ANNEX B-1. VALUE ENGINEERING REPORT

370939 CENTRAL EVERGLADES PLANNING PROJECT FEASIBILITY PHASE

VALUE ENGINEERING STUDY REPORT

February 2013
(Updated January 2014)

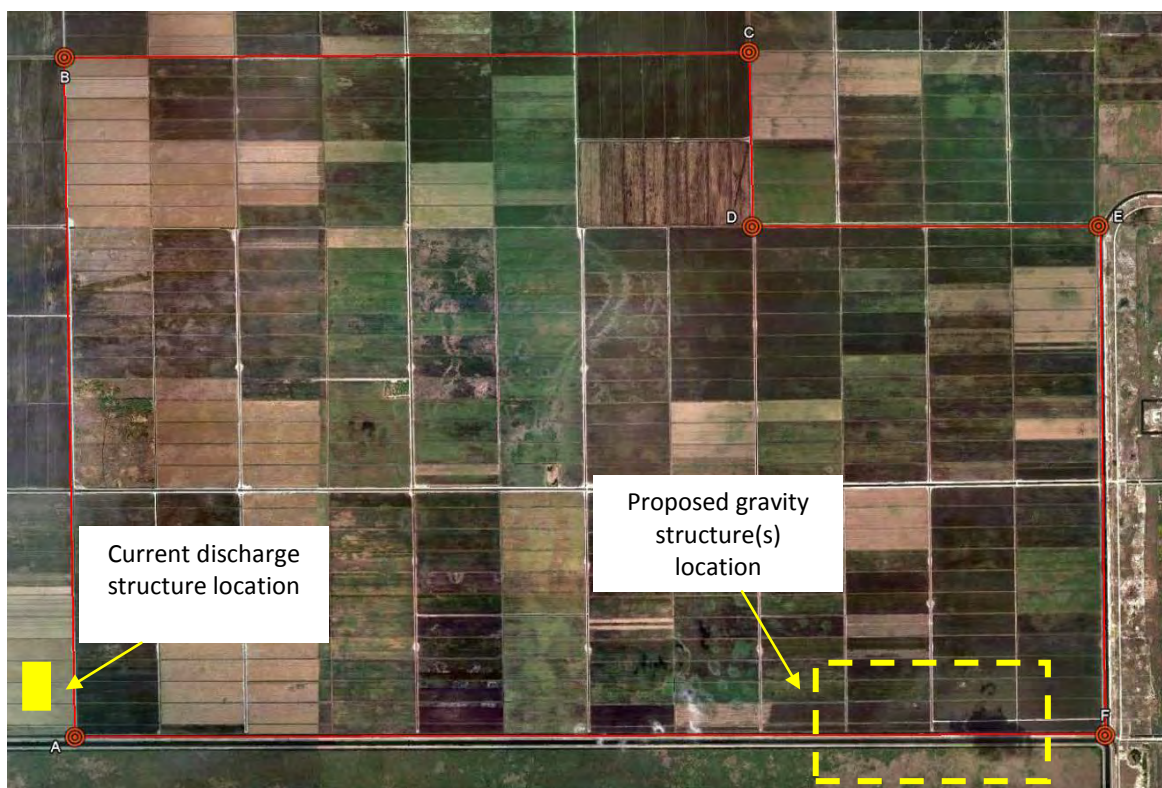
NR-1 Add outflow gravity structure on SE corner of A-2 - The currently proposed design of the A-2 FEB has one outflow structure, DS-7, located on the western perimeter discharging via an outflow canal to the headwaters of G-372. G-372 will be responsible for providing the lift to convey the discharges through the STA 3/4 Supply Canal toward the STA 3/4 inflow structures. A recommendation was made to place gravity outflow structures along the southeast corner of A-2 (see map below). This would be possible as long as the stages in STA 3/4 Supply Canal were low enough for water to pass from the FEB (max stage of 13.0 NGVD – natural grade at 9.0 NGVD with 4 ft depth). The STA 3/4 Supply Canal design stages for HW (G-372 TW) and TW (STA 3/4 Inflow structures HW) are 17.0 NGVD and 15.0 NGVD, respectively.

Using the same period of record (01-June-05 to 31-Dec-05) to compare historical G-372 TW stages and modeled FEB stages, data shows that FEB stages exceed G-372 TW stages on average 0.42 ft for a total of 68 days out of 214 days (31.78%). If the proposal is adopted, structures would most likely be culverts with flap gates (reference below graphs).

Preliminary disposition: Address recommendation in project design phase.

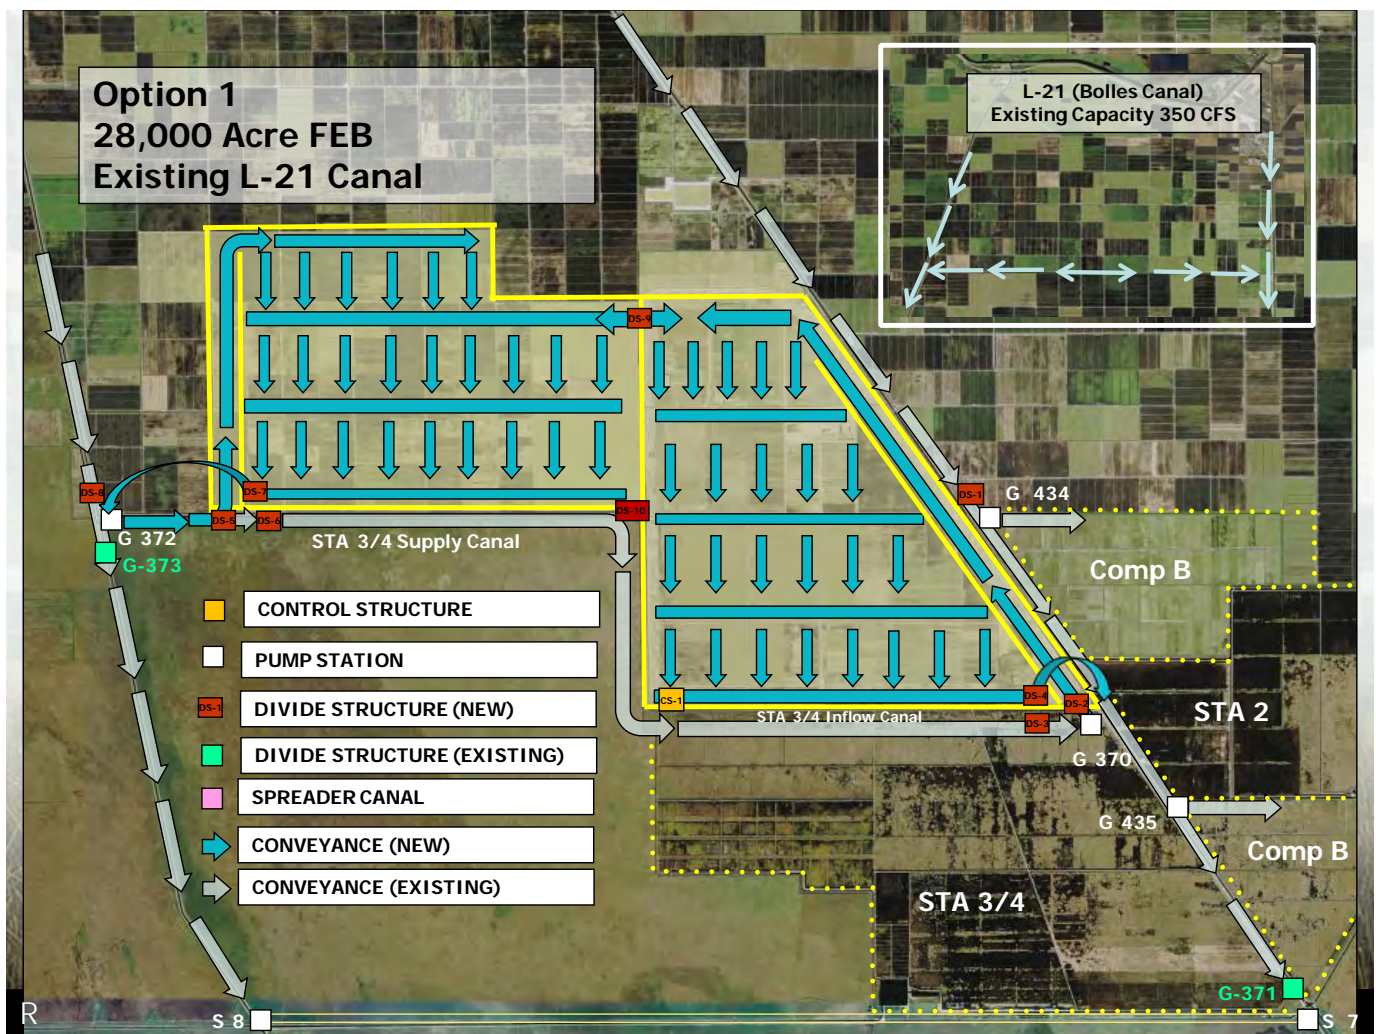
NR-2 Add in-line structure for North New River Canal - The structure in the North New River Canal is an in-line structure that would be located just north of Compartment B, upstream of Pump Station G-434. (See DS-1 in Figure below.) It would allow water from the A1 and A2 FEB's to be discharged into the North New River Canal without mixing with untreated water. At that point, treated water could either be pumped into Compartment B or STA 3/4 for further treatment. Initial modeling results indicate that DS-1 may not be needed for A1 to function, but further modeling and design of the A-1/A-2 FEB combination may indicate that DS-1 is needed.

Preliminary disposition: Address recommendation in both current plan development and project design phase.

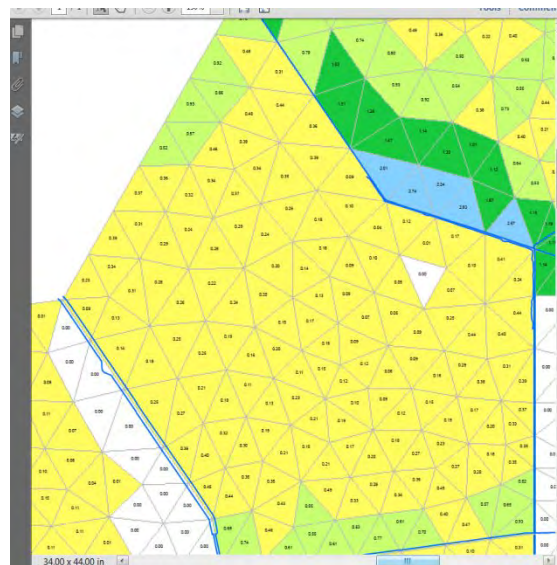
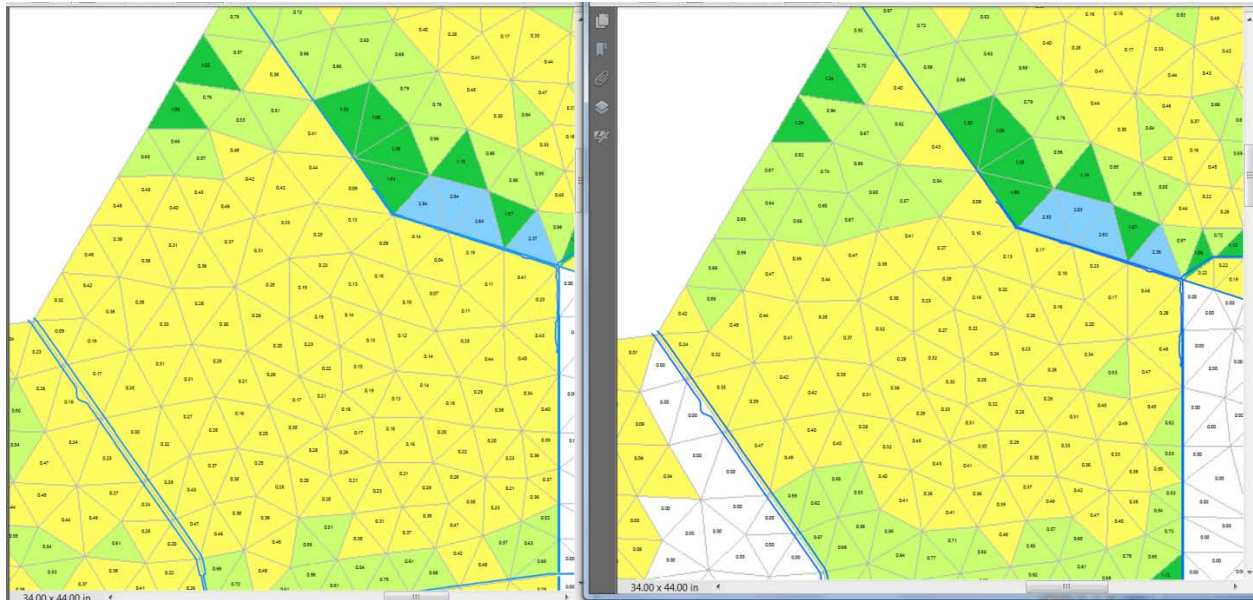
SR-1 Add AM strategy for G-336G (L6 Diversion) - As part of the CEPP TSP, L-6 diversions of STA treated water that normally would go to WCA 2A would be routed to the L-5/L-4 canals for distribution in WCA 3A. This results in unintended consequences to lowering WCA 2A (see ponding figure in dry season below) and can result in risk of dryouts and fires beyond what it currently experiences. G-336G (see pictures below) is a structure along the L-6 levee in between the EAA and WCA 2A that could potentially be used or retrofitted to help add water during dry periods to avoid drying out of WCA 2A beyond the existing conditions. The structure needs to be examined to determine whether it is controllable to move water northeast or and southwest over a variety of conditions in the canal.

Preliminary disposition: Address recommendation in both current plan development and development of the Adaptive Management Plan.

Figure1. Draft targets above represented as black line on existing 2A stage hydrograph (stage in NGVD on y-axis, water depth on x-axis).

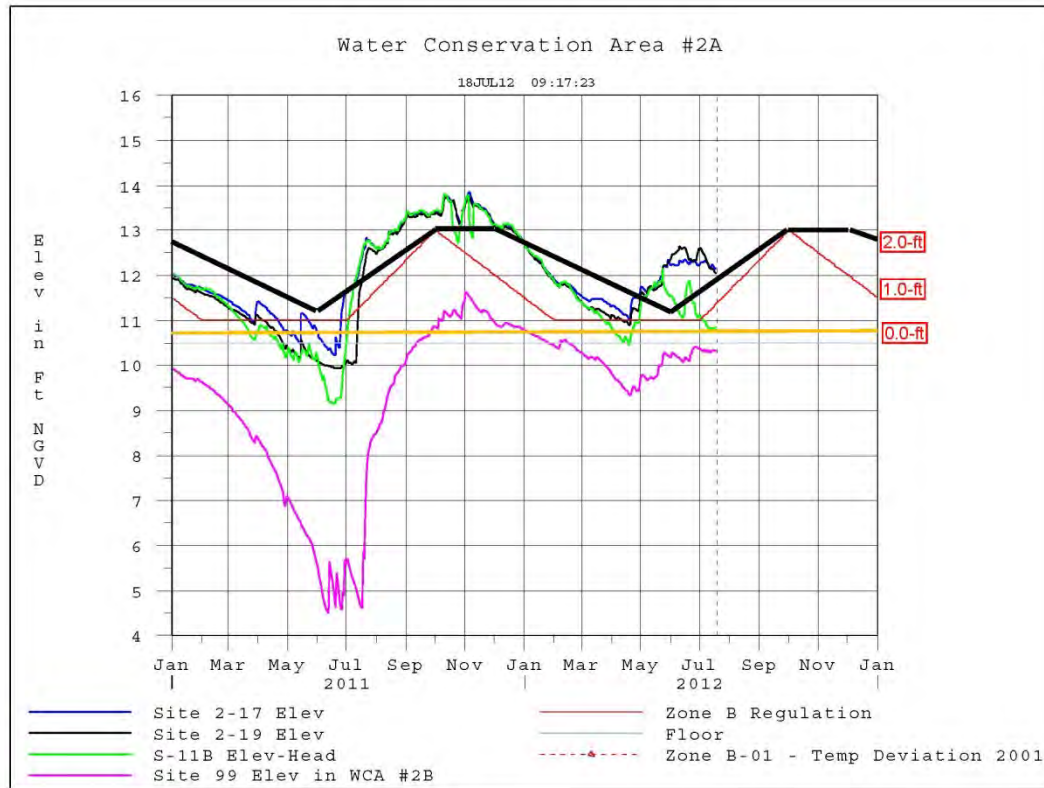
Purpose: To provide ecological targets and draft stage hydrograph (Figure 1) that more closely resembles an environmentally preferred *water management strategy for WCA-2A* (not intended to change the 2A regulation schedule).

1. Dry Season Low Recommended Depth Range (~June 1st): **0.0 – 0.5-ft**
2. Wet Season High Depth (~Oct 1st): Approximately **2.0 – 2.25-ft**
3. January 1 target depth range: **~1.8-ft**
4. Recession Rate Guidelines (January 1- June 1): **0.05 ft/wk** (snail kite preferred) – **0.07 ft/wk** (wood stork and state listed wading birds).
5. Ascension Rate Guidelines (June 1 – Oct 1) Maximum of **0.25 ft/week** and approximately **0.05 ft/wk** minimum. Preferred **0.05-0.15-ft**.

Assumption: Ground surface elevation of 10.75-ft NGVD (EDEN Wet Prairie Site 17). Ultimately, WCA-2A will need to join the periodic scientist calls for real-time water management with ecological recommendations for recession rates, ascension rates, and core foraging depths.

Preliminary disposition: Address recommendation in development of Adaptive Management Plan.

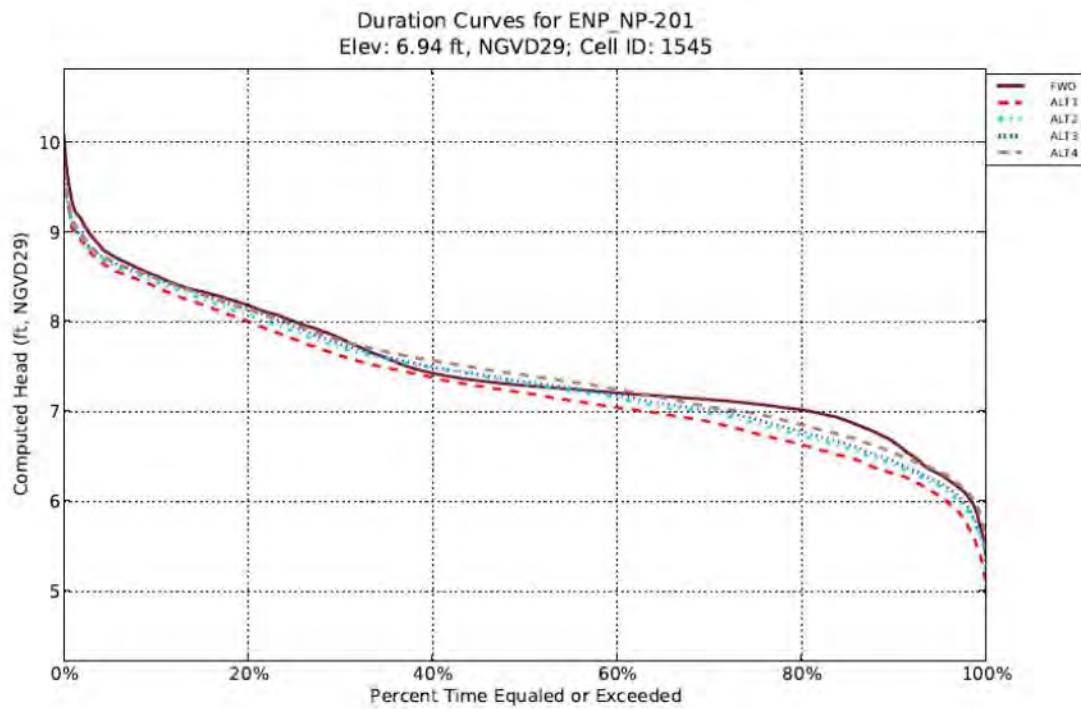
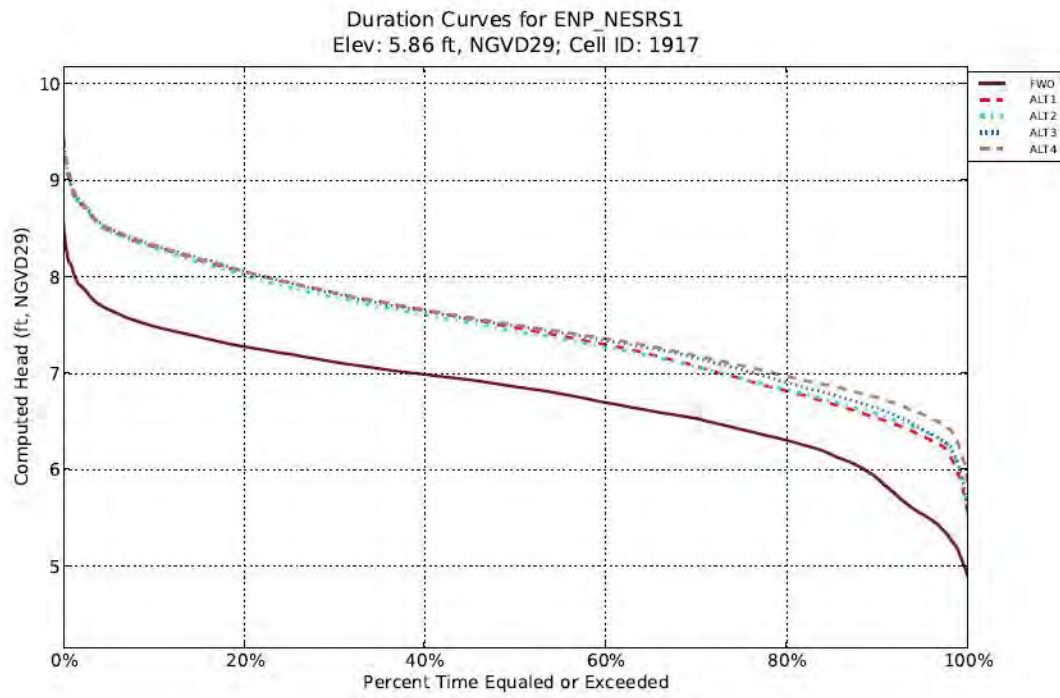
Option 1: Remove of 1.5 miles of the L-67 Extension Levee and Canal (modeled CEPP Alternative 1). Removal of ~1.5 miles of the L-67 Extension Canal is anticipated to negligibly affect the outlet conveyance capacity of the S-12C and S-12D (previously considered with the MWD Project), and would not likely require mitigation through removal of all or portions of this section of the Old Tamiami Trail. This option would provide reduced hydrologic connectivity between Western SRS and Northeast SRS, as compared to the TSP (although greater than the No Action condition). Depending on the CEPP flow distributions within other parts of the system, which is still being adjusted with ongoing modeling, the stage differential between CEPP Alternative 1 (1.5 mile L-67 Extension removal) and CEPP Alternatives 2-4 (complete L-67 Extension removal) are negligible at NESRS-1 (see Alternative 2) and minor at approximately 0.1-0.2 feet at NP-201 (see accompanying figures). The performance-based TSP selection of Alternative 4 was not critically dependant on the L-67 Extension configuration. Option 1 is also a potential adaptive management increment.

Option 2: Remove most or all of L-67 Extension Levee and do not fill canal (not modeled in CEPP alternatives). This option would provide hydrologic connectivity between Western SRS and Northeast SRS, comparable to the CEPP TSP performance. A modest reduction in the outlet conveyance capacity of the S-12C and S-12D would be expected due to the increased hydrologic interaction between S-333 and the S-12s, although this may be offset with the significant reduced regulatory reliance on the S-12s with CEPP implementation (as modeled). Complete removal of the segment of Old Tamiami Trail would not be required and the L-67 Extension Levee material could be utilized for other CEPP components (i.e. Blue Shanty Levee), potentially with material processing requirements.

Preliminary disposition: Address recommendation in development of Adaptive Management Plan.

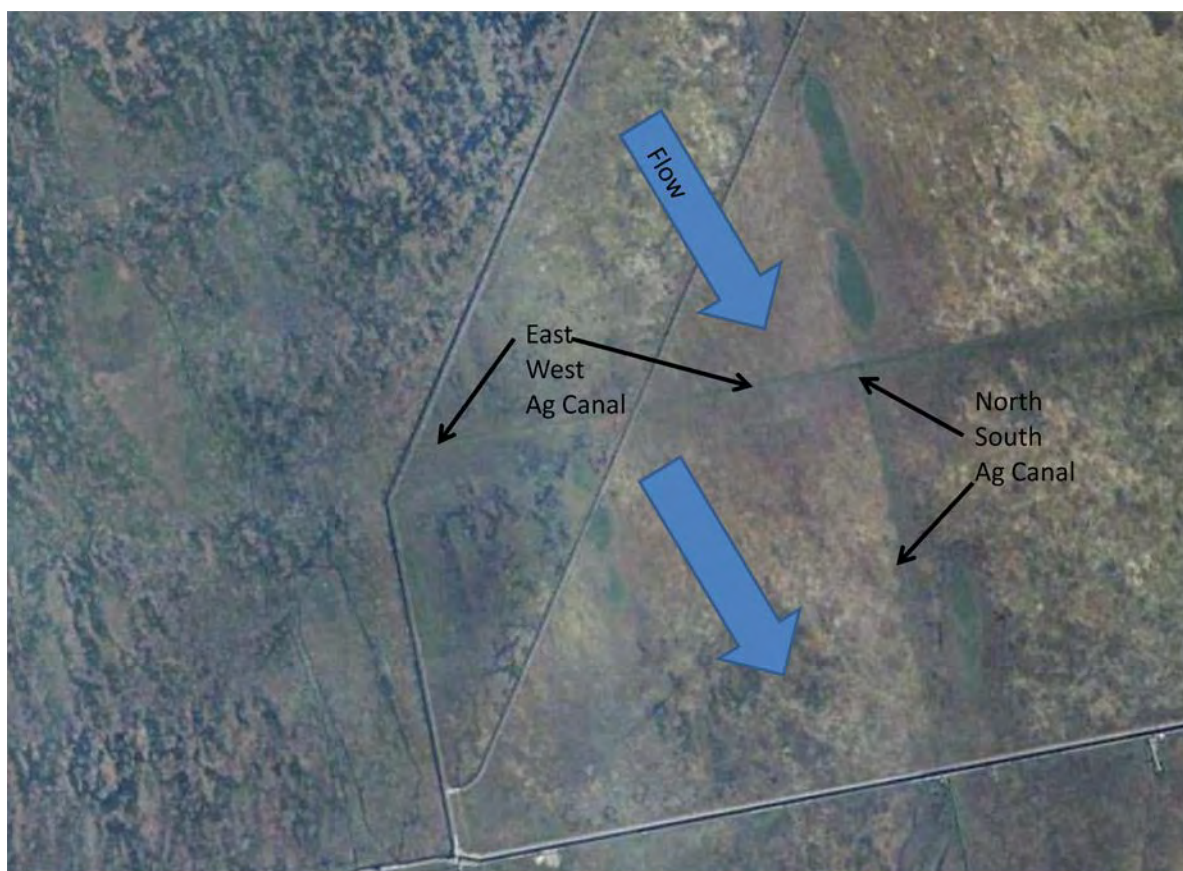
GB-2. Consider extending S-355B collector canal - Ongoing CEPP TSP adjustments and associated hydrologic modeling have included recommendations to increase stages within eastern WCA-3B, east of the Blue Shanty levee, compared with Alternative 4 stages. The TSP cost estimate included placeholders for potential conveyance improvements within the WCA-3B remnant agricultural ditches, east of the Blue Shanty levee. The conveyance improvements were intended to improve the ability to achieve north-to-south flows from eastern WCA-3B to the L-29 Canal, via the existing S-355A and S-355B gravity spillway structures.

Since the CEPP TSP does not include additional WCA-3B outlet structures for eastern WCA-3B, this proposal would extend the existing 1000 foot upstream collector canal for S-355B by 0.4 miles (~2100 feet) to tie-in with the Central remnant north-south agricultural ditch (with associated conveyance improvements to the Central remnant north-south agricultural ditch and the remnant east-west agricultural ditch), as shown in the below map. By providing a hydrologic connection between the S-355B collector canal and the remnant agricultural ditches, the efficiency and quantity of conveyance from southern WCA-3B to the S-355B will be improved (degree is dependent on operating stages within WCA-3B and design details). Gravity outflow from WCA-3B will remain dependant on managing water levels within WCA-3B higher than stages in the L-29 Canal, east of the proposed CEPP L-29 Divide structure. CEPP stakeholders have expressed concerns with significant increased water management stages within WCA-3B, without providing sufficient WCA-3B outlet capability. Collector canal construction would impact at minimum 7-10 acres of WCA-3B wetlands located along the interior toe of the L-29 Levee, assuming current dimensions of the S-355B collector canal.

The S-355A and associated collector canal is located east of the proposed Blue Shanty levee and 1.7 miles west of the Central remnant north-south agricultural ditch. The Western remnant north-south agricultural ditch is located within the footprint of the proposed Blue Shanty flow-way. The proposed S-355B collector canal extension represents the minimum amount of additional collector canal construction that would improve the capability to utilize the existing S-355s to convey water out of WCA-3B. Construction of a new gravity culvert structure at the southern terminus of the Central remnant north-south agricultural ditch could be considered as an alternative to the extension of the S-355B collector canal. These options have been previously proposed for consideration during the MWD Project.

Preliminary disposition: Address recommendation in both current plan development and development of the Adaptive Management Plan

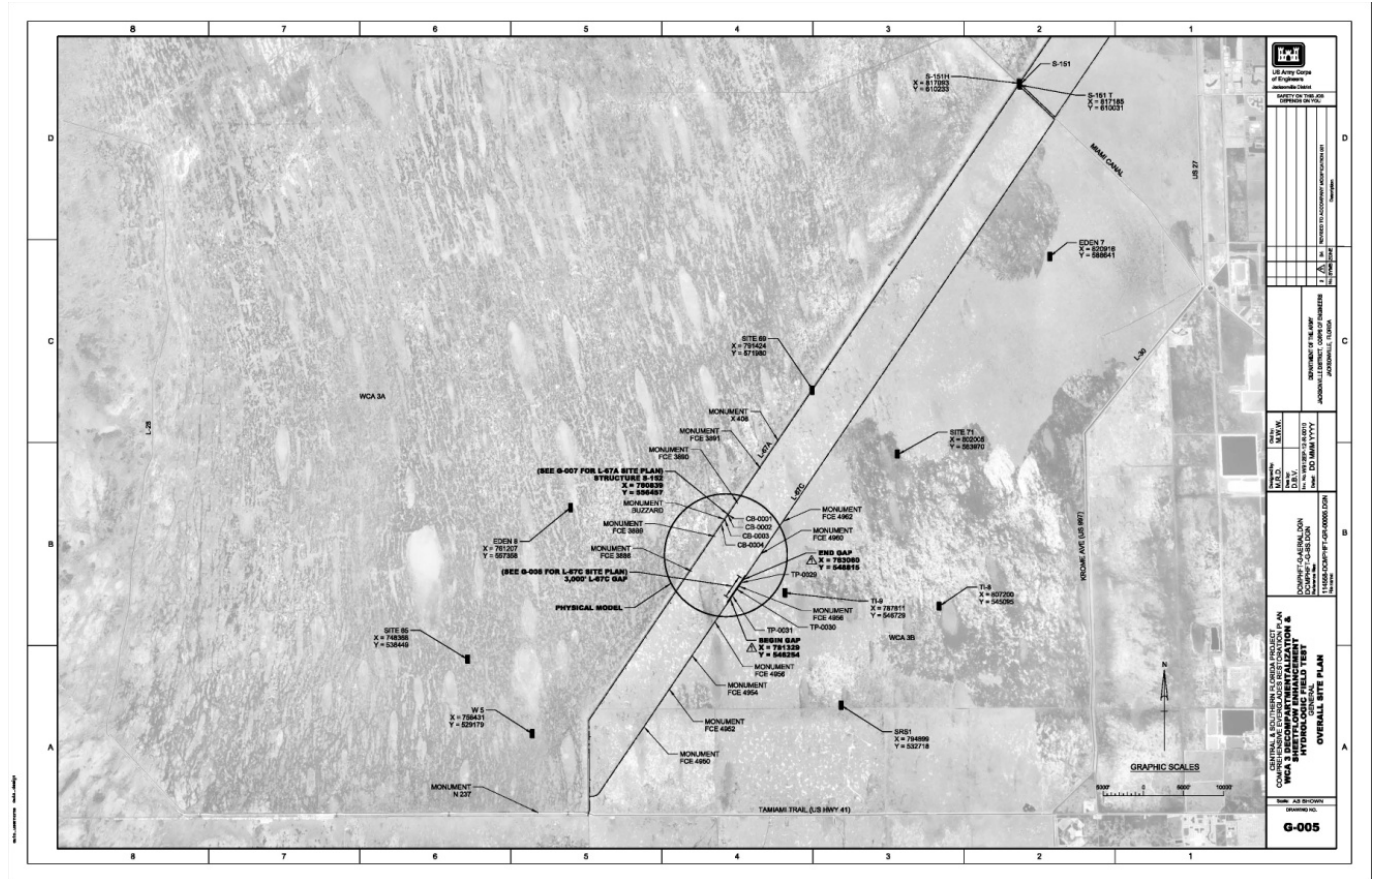
GB-5 Retrofit DPM structure (S-152 800 cfs 10 - 60" HDPE barrels); Use DPM structure for interim period - USACE and SFWMD entered in a design agreement May 12, 2000 for purposes of conducting activities related to planning, engineering and design of CERP projects. The Decom Physical Model known as DPM project was permitted as a large-scale field test designed to answer uncertainties with depth, hydroperiod, sheetflow and canal backfilling associated with the full-scale CERP DECOMP project. It was designed for a 5 year life cycle to go in place and be removed between 5-10 years as described in the DECOMP DPM Design Test Documentation Report. The DPM contract is scheduled for completion 2013. L-67C 3,000 ft gap was completed in Nov 2012. Plan is to conduct test for 2 years after construction complete for (2 months) of each year. Part of the permitting also conceptually approved de-installation (removal) of S-152, excavation of backfill material from L-67C canal, L-67A and L-67C levee reconstruction and finally removal of temporary access roads and spoil areas (see below drawing).

This VE recommendation proposes to retrofit the existing temporary (S-152 test structure) that was designed within the constraints noted above (design test, temporary nature, easily removable materials after test complete). A second part of this proposal is allow DPM components to remain in place and use it to continue to collect information through CEPP Adaptive Management. PROS – The existing temporary structure can be operated to see how 3B responds and what benefits you will achieve moving existing water through 3B and potentially the proposed flowway. CONS- maintenance responsibilities of the structure and functionality if left in place longer than the 10 year design life concept. It affects material selection as well as potential problems for seepage of the culverts. This idea is something that could merit consideration for the VE Report and further investigation during PED detail design phase.

Preliminary disposition: Address recommendation in both project design phase and development of the Adaptive Management Plan
